Addendum #1

RE: REQUEST FOR TENDER #2024-137-P01947
Hess Street Elementary School – Renovation Project

Addendum No. 1

PROJECT:	HWDSB Hess Elementary School	DATE:	April 24 th , 2024
PROJECT #:	23035	FROM:	Binayak Raj Maurya
TO:	NGA Architects	ATTENTION:	Ivana Paukovic

SHEET NO.	PROJECT NO.	CHECKED BY
M 1.01	23035	BM
SCALE:		AS NOTED

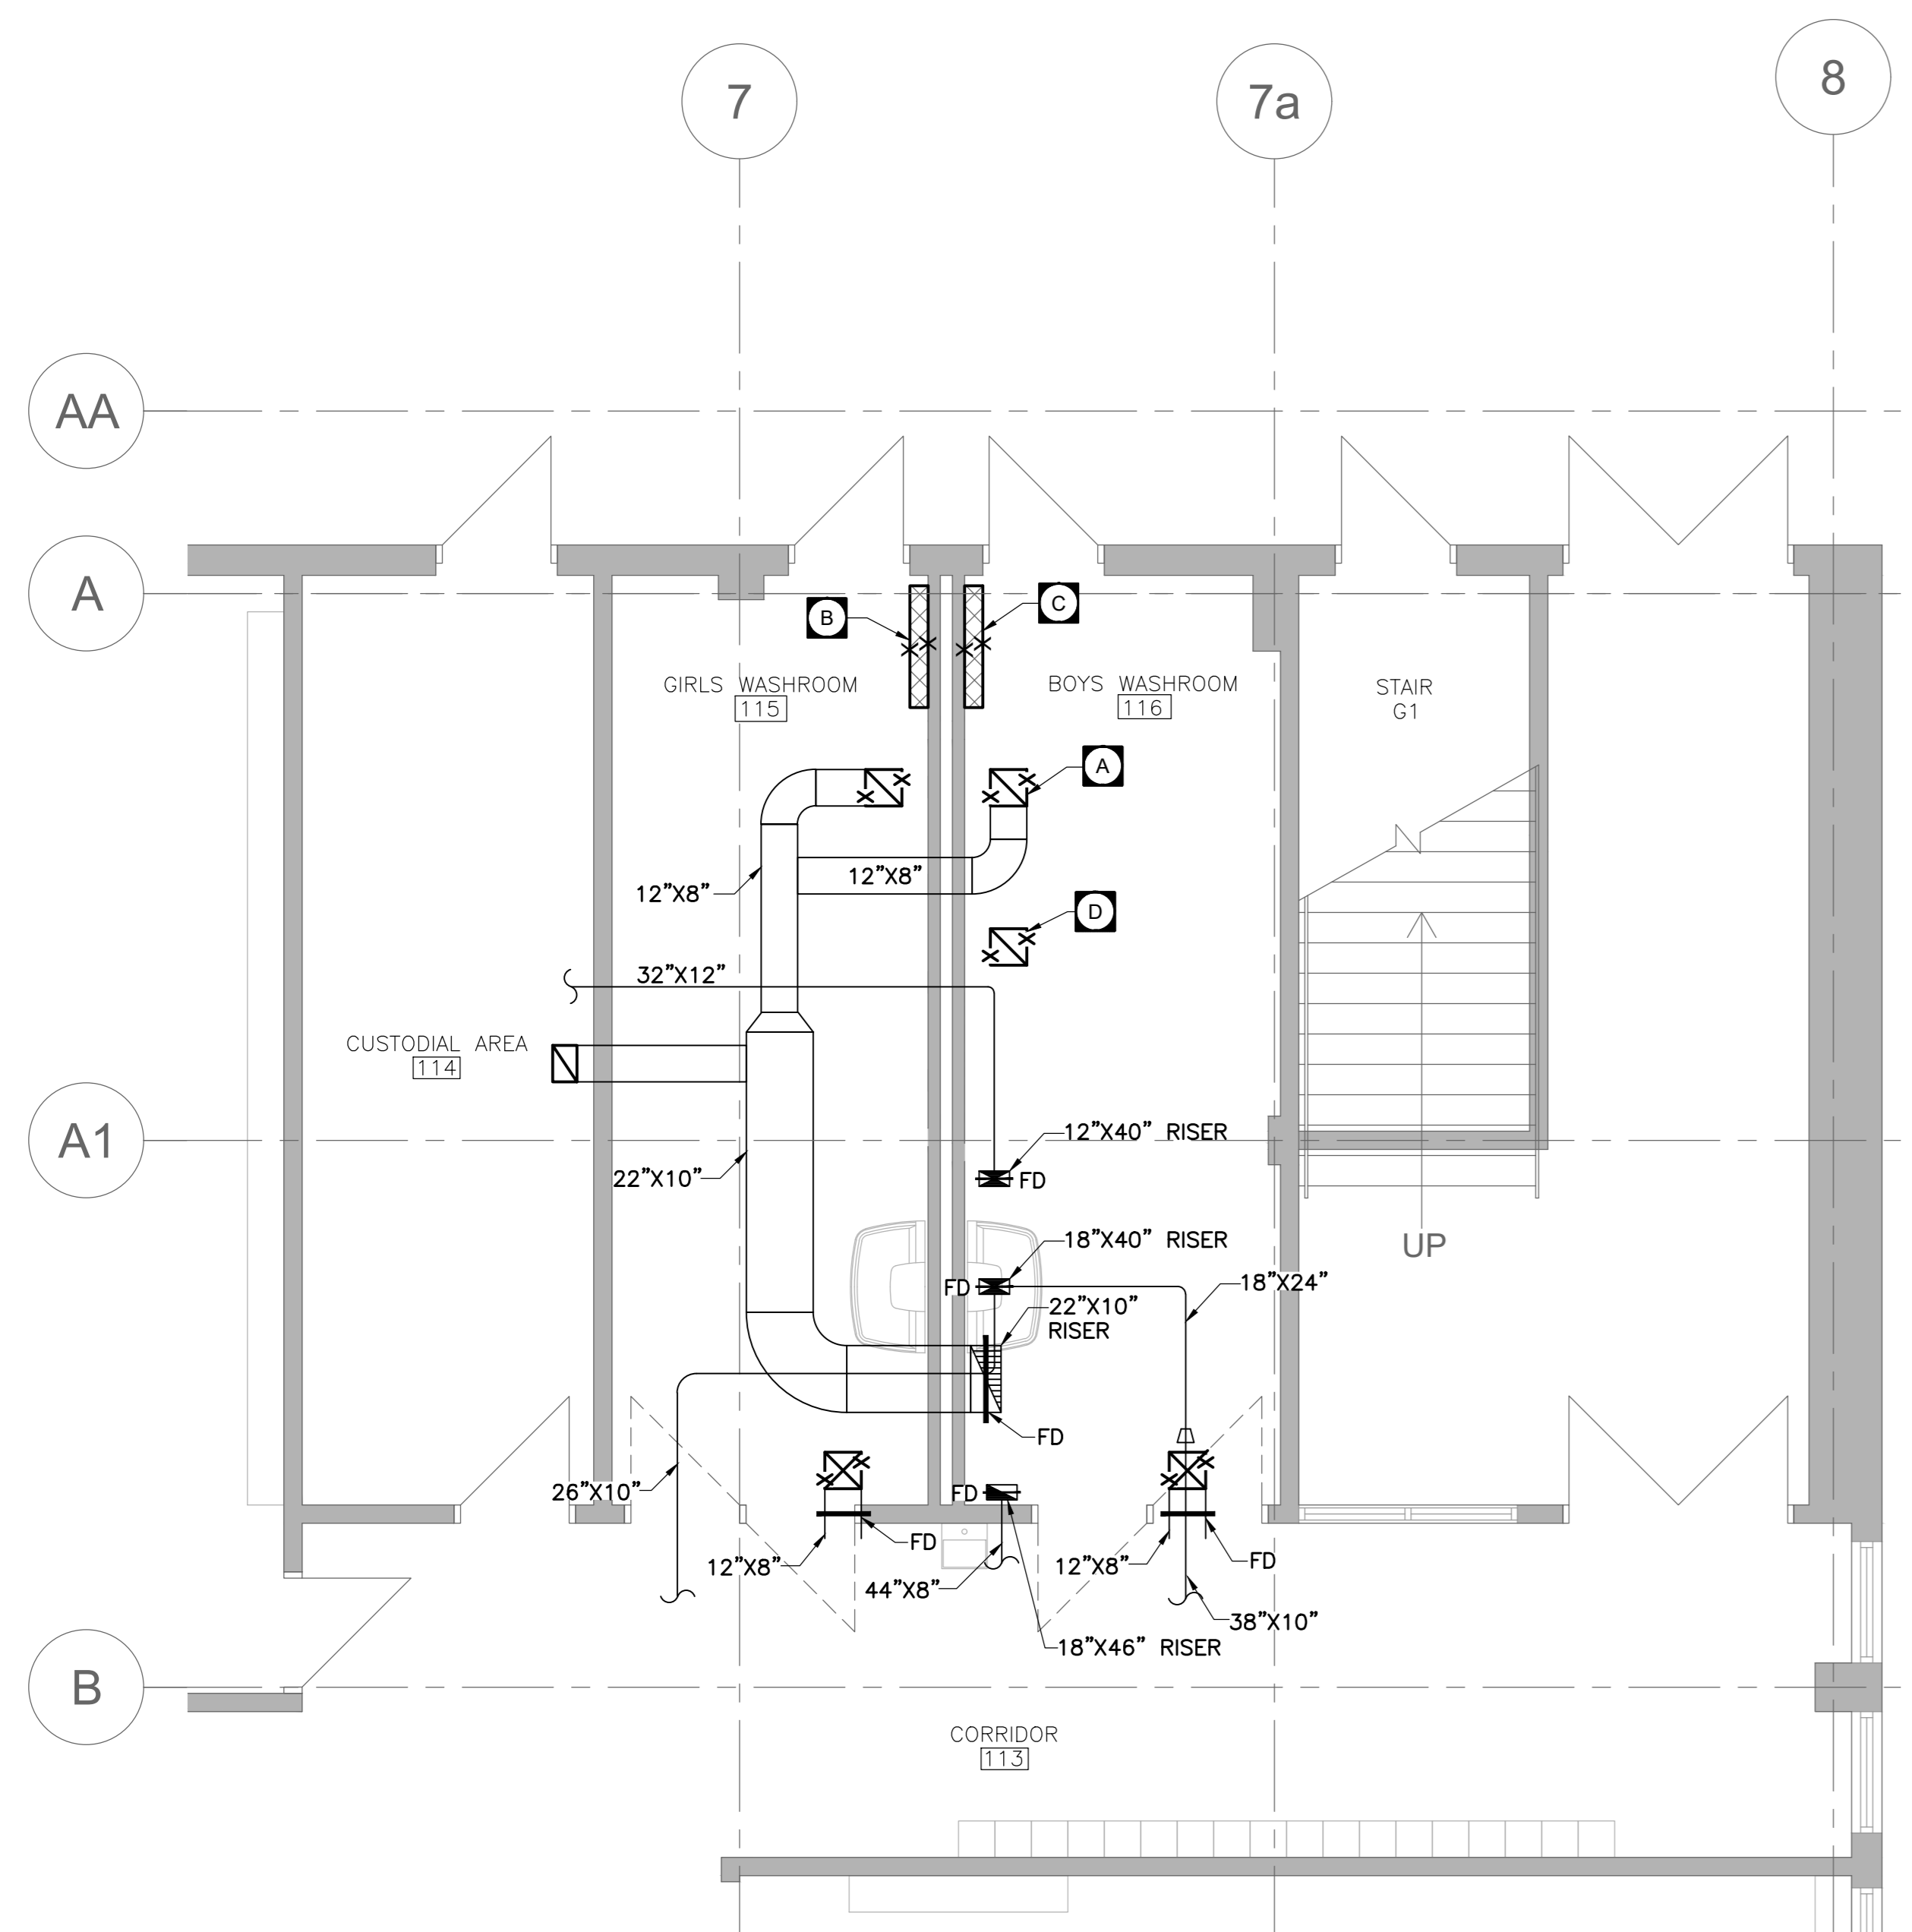
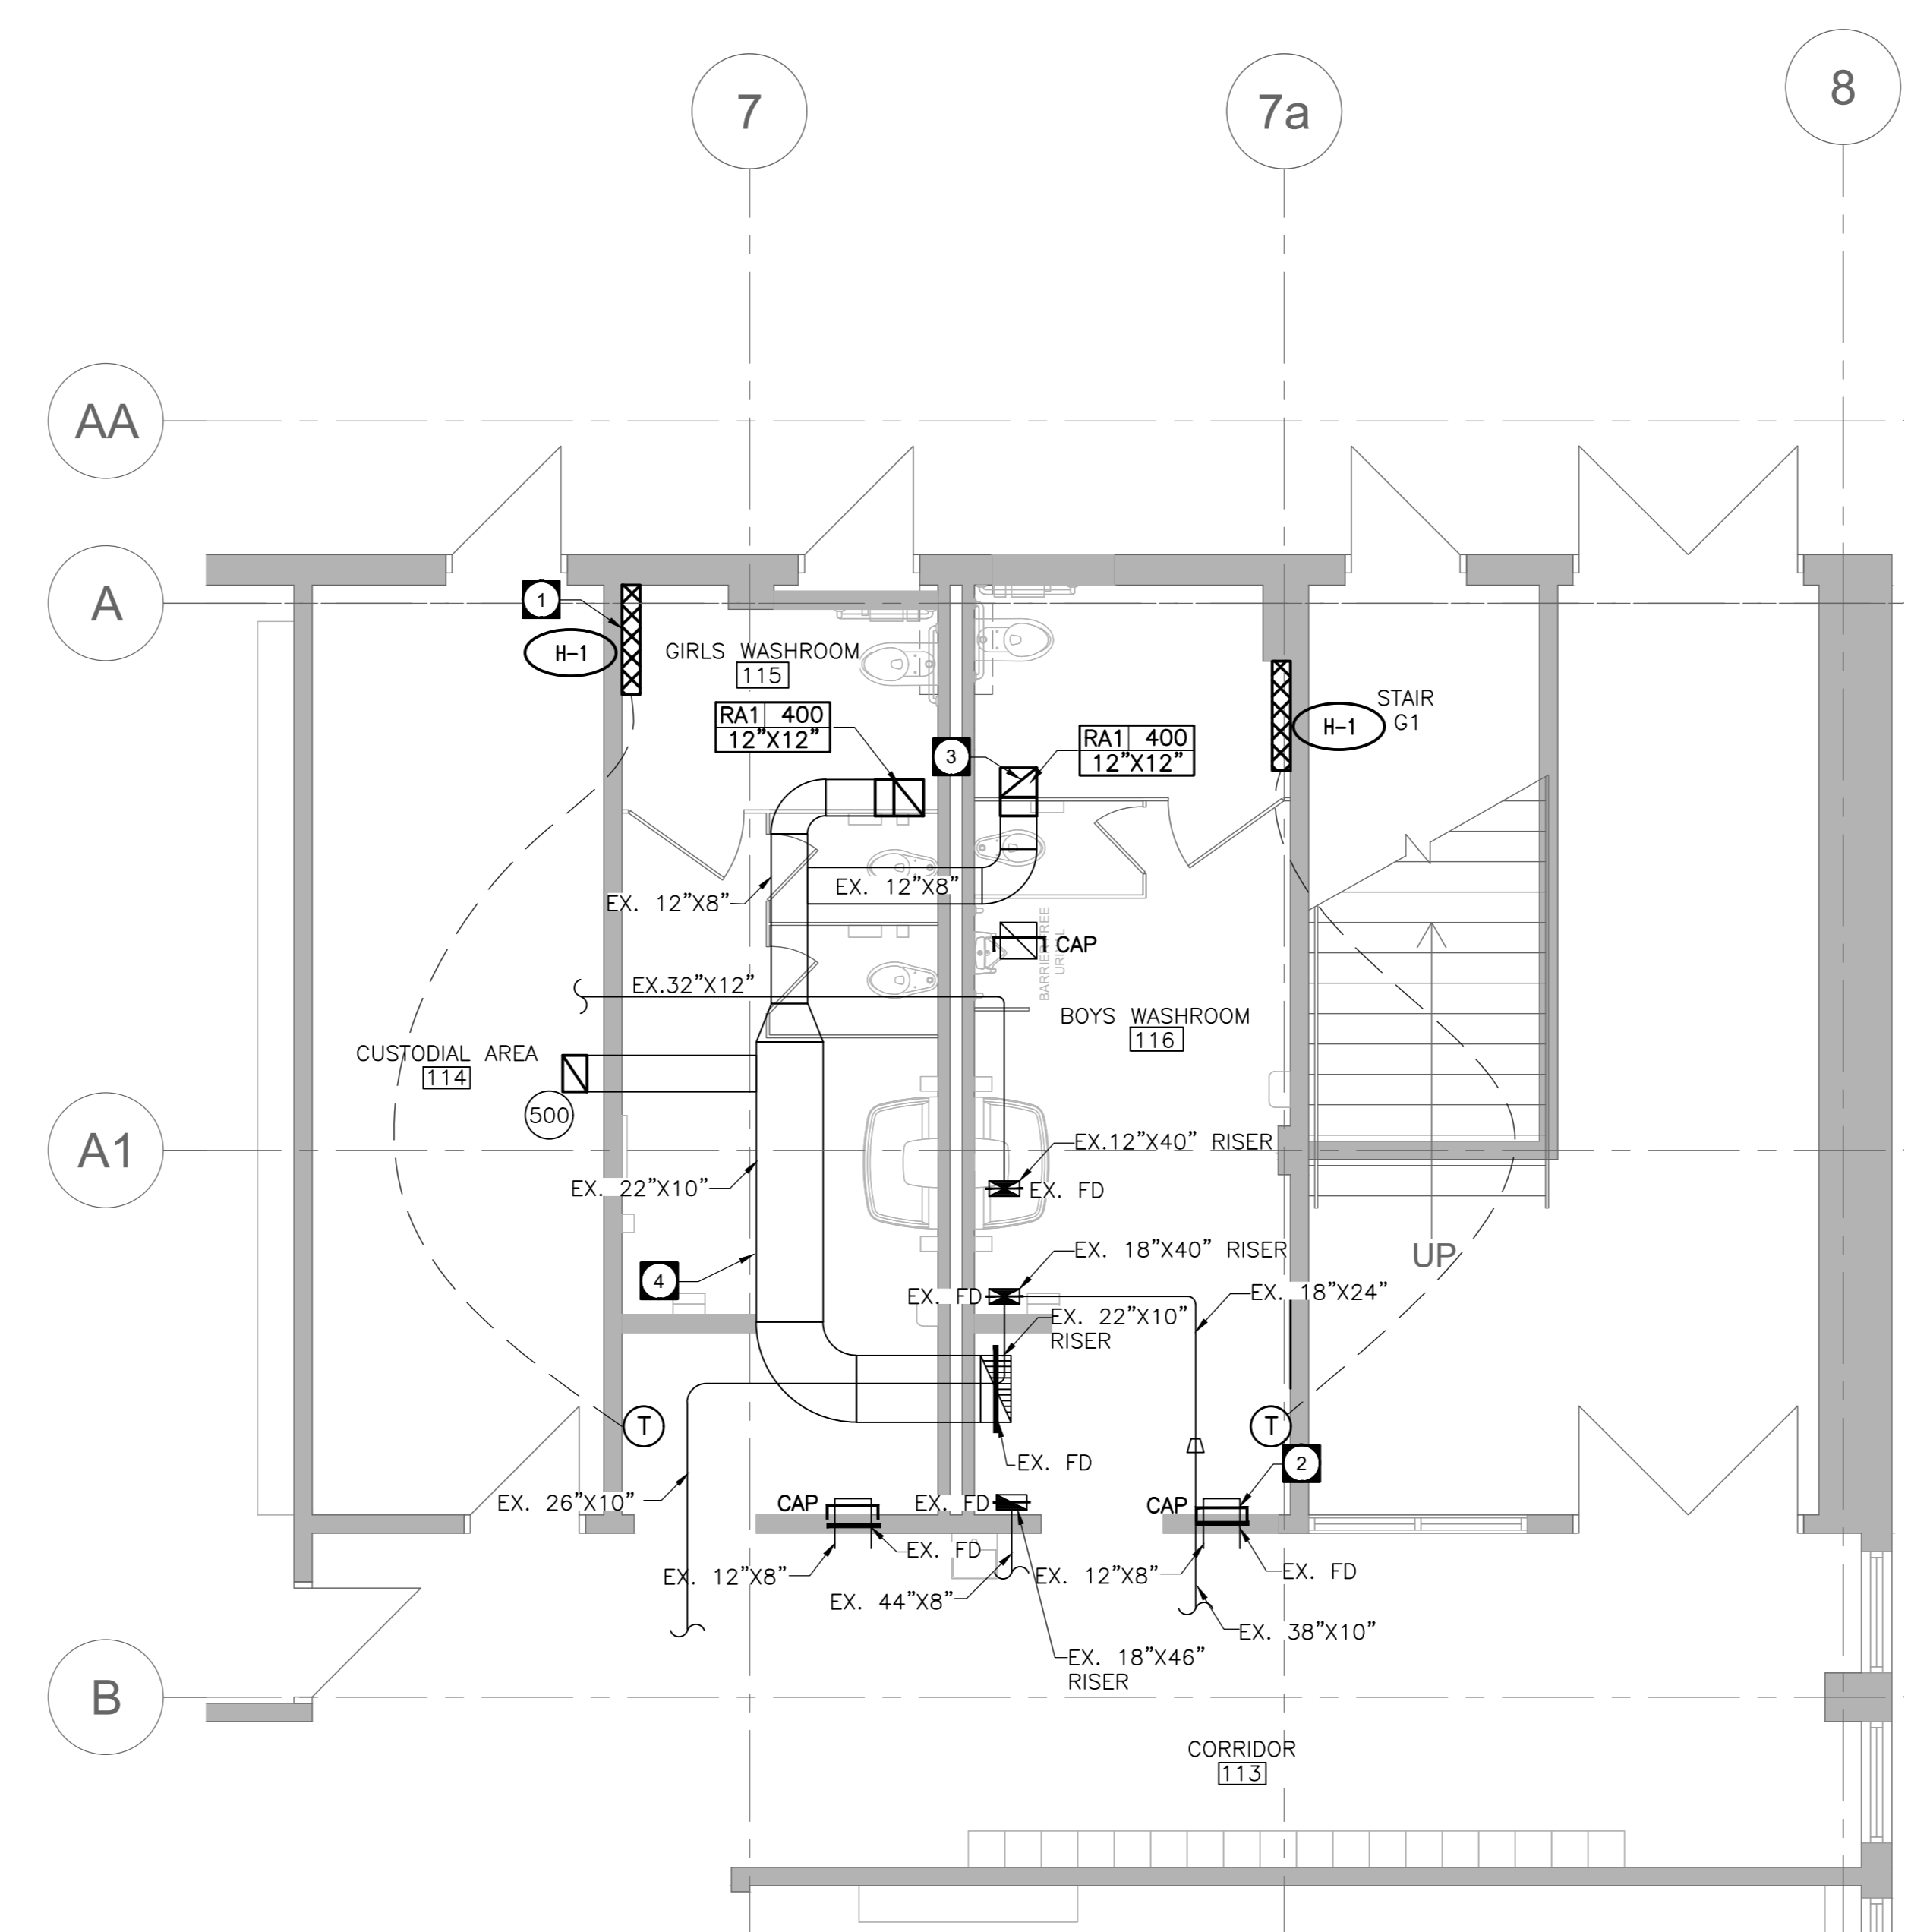
- 1) **Question:** On drawing M1.01, demo and new gym layout there is a reference to note 5. There isn't a note 5 under the new drawing notes.

- 4) **Question:** In various places on the drawings there are cross hatched symbols along the walls with no notes or references to what these are. What are these?

1.2 Refer to Mechanical Drawing M 1.01 Rev. C

- New note number-5 stated as “PROVIDE NEW TRANSER AIR GRILLES AS INDICATED” was added in the new drawing notes table.
- “EX. HEATER TO REMAIN” tag has been shown at the locations of existing wall fin heaters in Gymnasium-105.

Answer: Added note for new transfer grille. Refer to attached Addendum No. 1 by CK Engineering Inc dated April 24, 2024.

Answer: Existing heaters to remain. Refer to attached Addendum No. 1 by CK Engineering Inc dated April 24, 2024.
